Model: B-C3.5(Katana-C1.5)	Date: 21-May-08	No.: RD101001a
-----------------------------------	-----------------	----------------

Subject: Firmware Release Note:Option IPDS		Prepared by: T.Tadokoro	
From: PPBG QA/Service Planning Dept.			
Classification:	<input type="checkbox"/> Troubleshooting <input type="checkbox"/> Mechanical <input type="checkbox"/> Paper path <input checked="" type="checkbox"/> Other ()	<input type="checkbox"/> Part information <input type="checkbox"/> Electrical <input type="checkbox"/> Transmit/receive	<input type="checkbox"/> Action required <input type="checkbox"/> Service manual revision <input type="checkbox"/> Retrofit information

Model: Bellini-C3.5 (Katana-C1.5 Type-A/B/C)		Date: 25-Jul-08	No.: RD101022
Subject: Firmware version for Katana-C1.5 with Plockmatic or IPDS option		Prepared by: T.Tadokoro	
From: PPBG QA/Service Planning Dept.			
Classification:	<input type="checkbox"/> Troubleshooting <input type="checkbox"/> Mechanical <input type="checkbox"/> Paper path <input type="checkbox"/> Product Safety	<input type="checkbox"/> Part information <input type="checkbox"/> Electrical <input type="checkbox"/> Transmit/receive <input checked="" type="ch

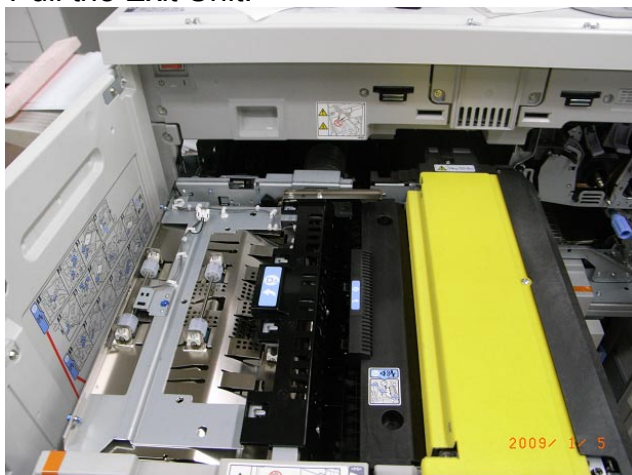
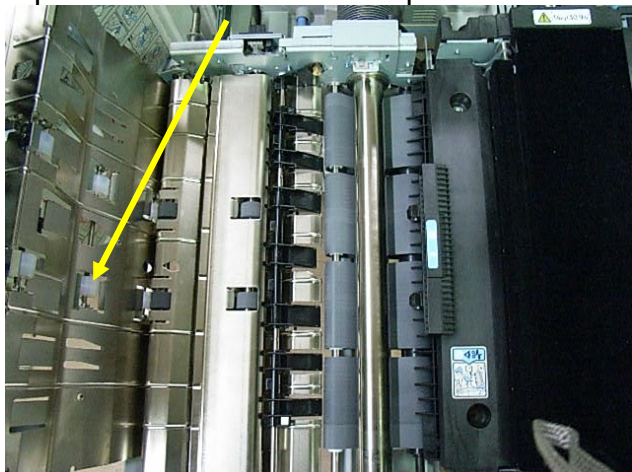
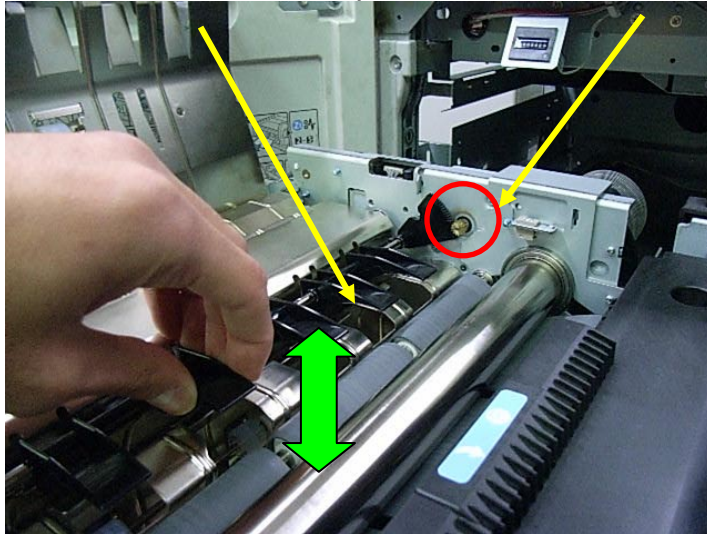
Please move Gate Pawl (B2344455) manually when the mainframe is installed. This action confirms that the motor rotates properly and will release a (possibly) locked motor.

1. Pull the Exit Unit.

2. Open the Exit Guide Plate upward.

3. Move the Gate Pawl upward and downward, then rotate the gear of the stepper motor.

42.Cleaning Unit 1 (B234/B235/B236/D101/D102/D103)

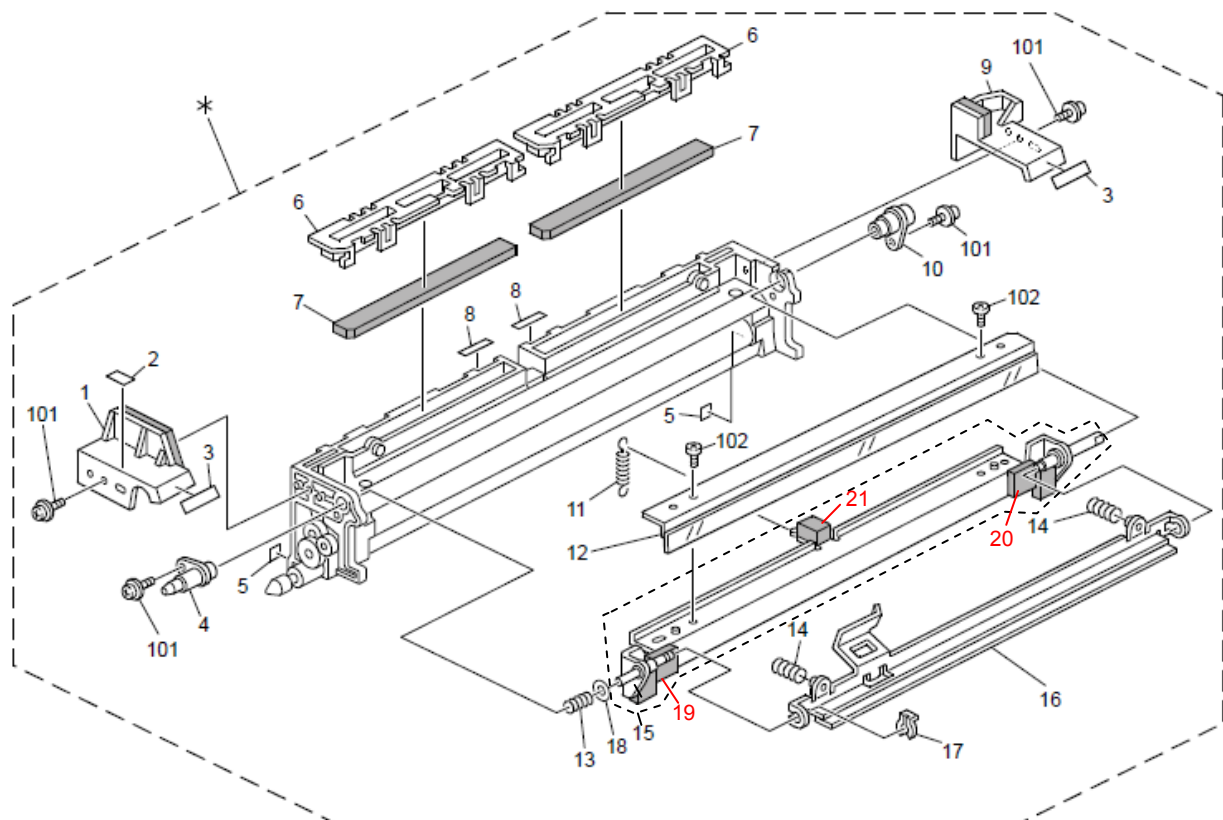
New part number	Description	Q'ty	Int	Page	Index	Note
B2343572	SEAL:BLADE:FRONT:ASS'Y	1	-	98	19	Add
B2343575	SEAL:BLADE:INNER BACK:ASS'Y	1	-	98	20	Add
B2343578	SEAL:BRACKET:BLADE	1	-	98	21	Add

Reason : Due to request from the field.

57.Duplex Unit 5 (B234/B235/B236/D101/D102/D103)

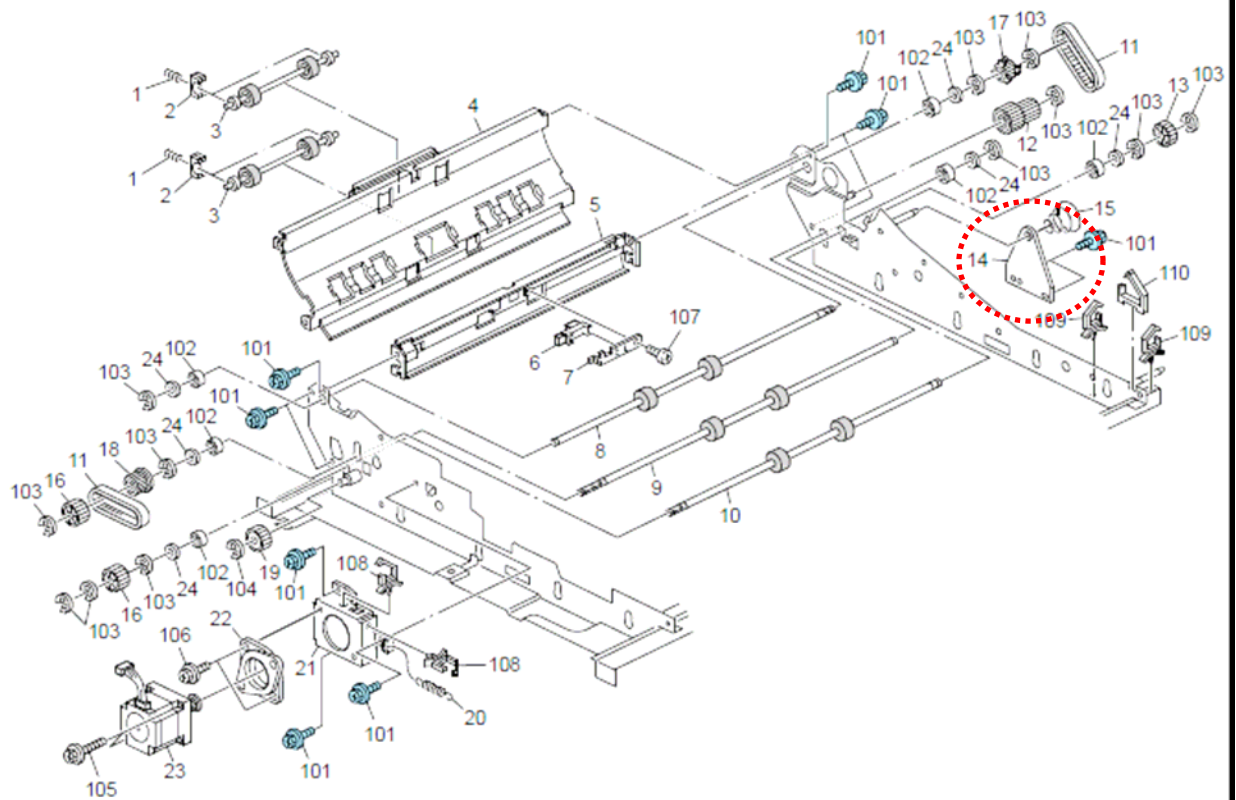
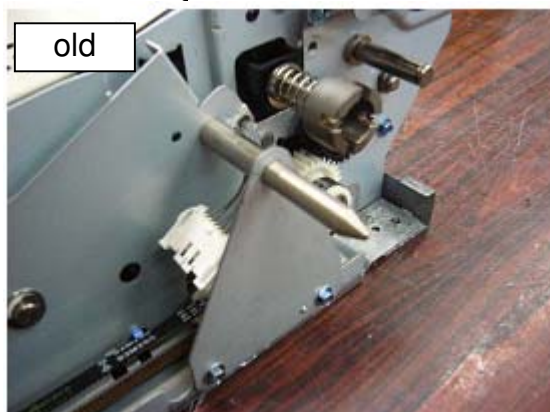
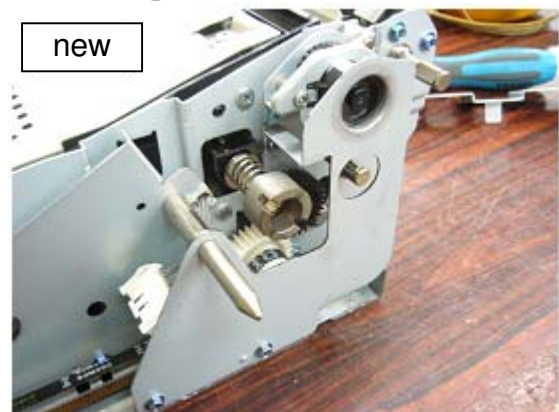
The support bracket has been modified ([B2344631](#) → [D0594632](#)) to prevent the possible breakage of the gear, which has also been modified for higher durability (B2344649 → D0594649).

The duplex unit also has a new p/n because of this modification.

- This modification also applies to Katana-C2, P1. Please refer to the corresponding RTB.
- Replace the gear (B2344649) with the modified gear (D0594649) if it breaks. If the breakage were to recur, please replace the duplex unit with the modified duplex unit installed with the NEW support bracket.
- The NEW support bracket (D0594632) cannot be installed on the old duplex unit (X/X).

Old p/n: B2344631

New p/n: D0594632

D0593644

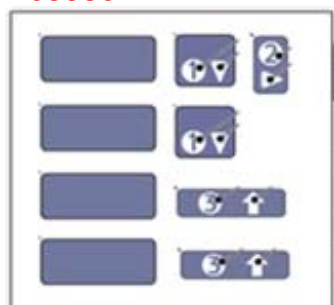
Change/Reason: We have combined four decals into one.

This modification has also applied to Katana-C1/C1.5 (B234/B235/B236/D101/D102/D103). Whichever the machine is, please order D0593644 when needing these decals.

24.Paper Feed Unit 1 (B234/B235/B236/D101/D102/D103)

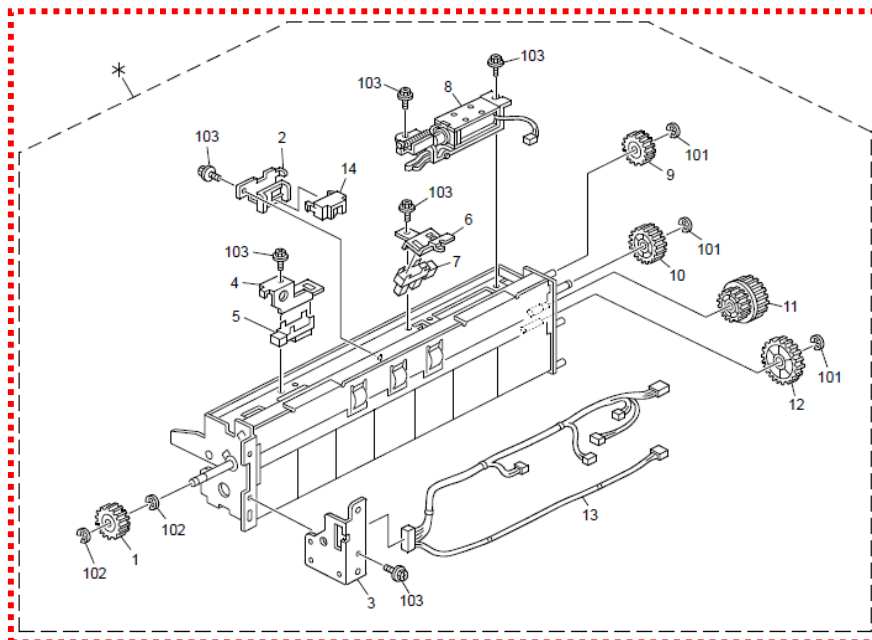
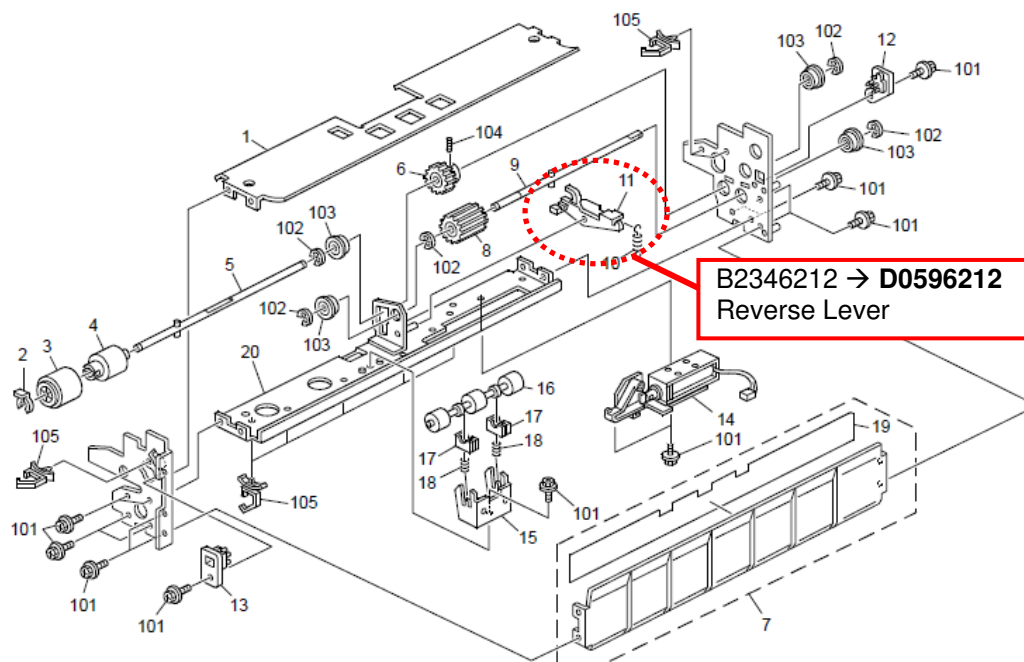
Insufficient pressure between the Feed and Reverse rollers could result in mis-feed jams. The shape of the component in the paper feed unit and the reverse lever have been modified, and the Reverse roller has been raised to a slightly higher position to maintain the optimum pressure between the two rollers.

- This modification also applies to Katana-C2, P1. RTBs have been issued for all models respectively.

56.Drive Section 5 (M002/M003/M004)

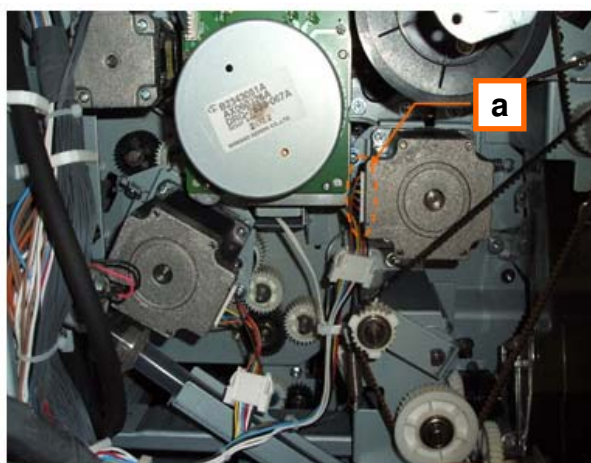
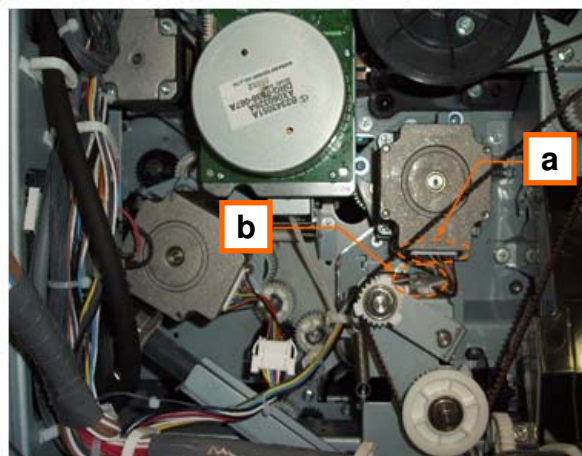
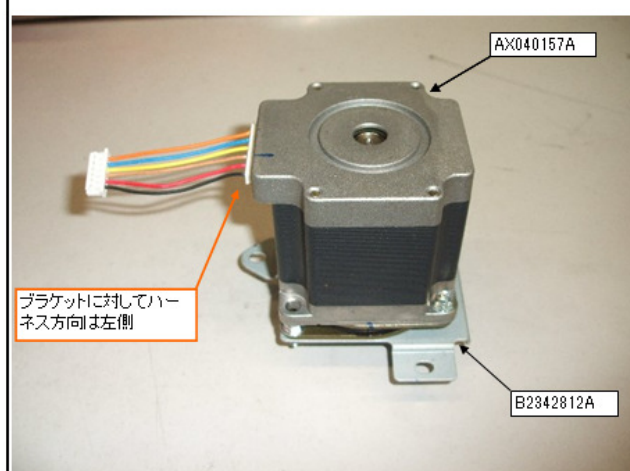
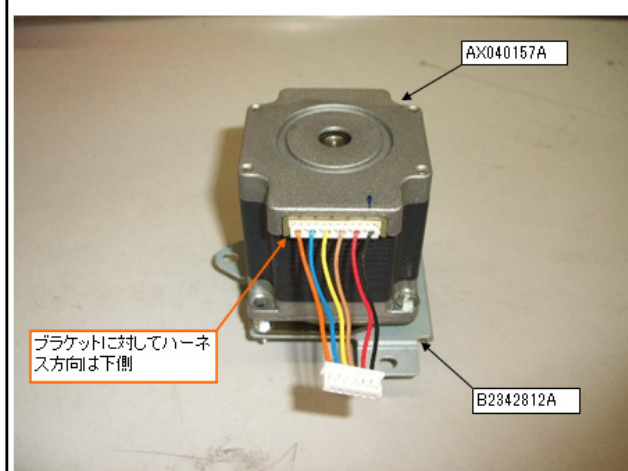
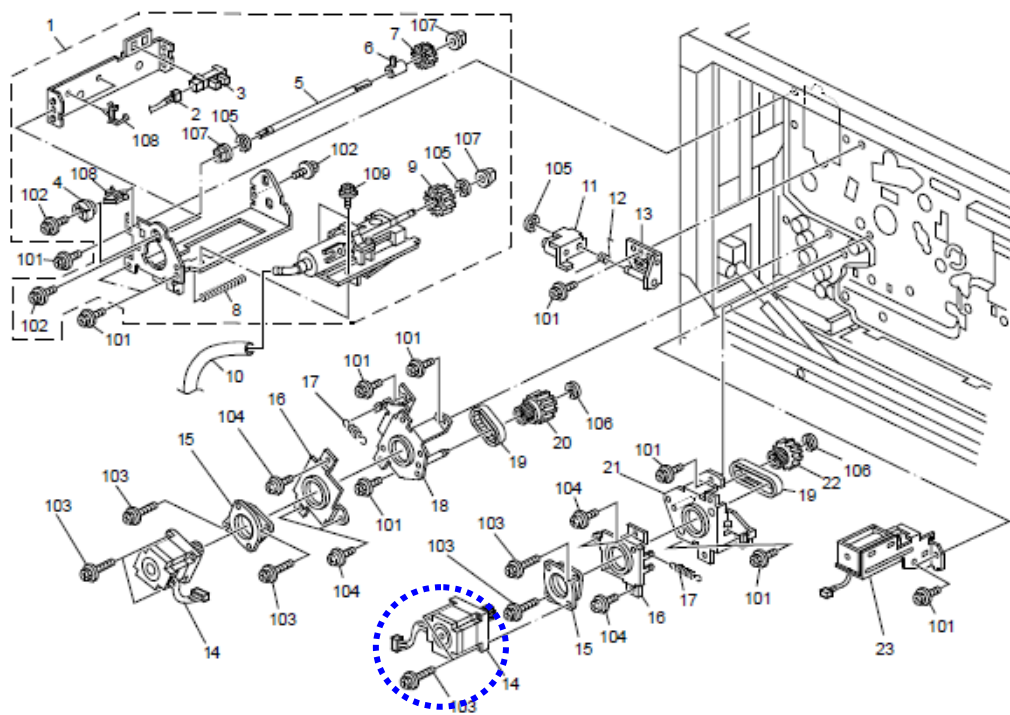
Change: a) Orientation of the DC Stepper Motor; 90 degrees counterclockwise
 b) Addition of a clamp (in accordance with the change in the motor orientation)

Reason: To prevent possible damage to the registration motor harnesses

NOTE: The newly added clamp is immediately below the harness connector of the motor indicated with the blue circle in the diagram below, and attaches to a bracket that is not registered as a service part.

The modification described in this bulletin also applies to ALL of the Katana Models (B234,B235,B236,D059,D060,D061,D101,D102,D103,M003,M004).
